UNITED STATES PATENT AND TRADEMARK OFFICE

Office Action Summary	Application No. 10/777,809	Applicant(s) LEWIS, ANTHONY GORDON	
	Examiner David T. Fidei	Art Unit 3728

DETAILED ACTION

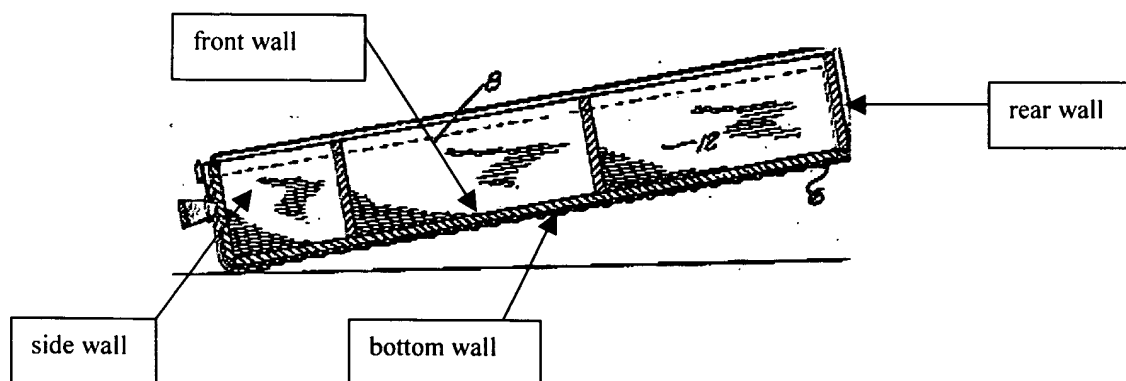
As to claims 2, 4, 5, 7 it is a matter of convention as to what one considers a front, rear, bottom and sides walls in Ritter, Jr. As depicted below, a “front” is considered as that wall defined on the outside of section 8, the opposite side is considered the “rear wall” with the “bottom wall” defined at the right with the remaining peripheral walls defining “side walls”.

As shown above, three compartment are defined by the transverse wall extending upward from the front wall, as per claims 9-11.
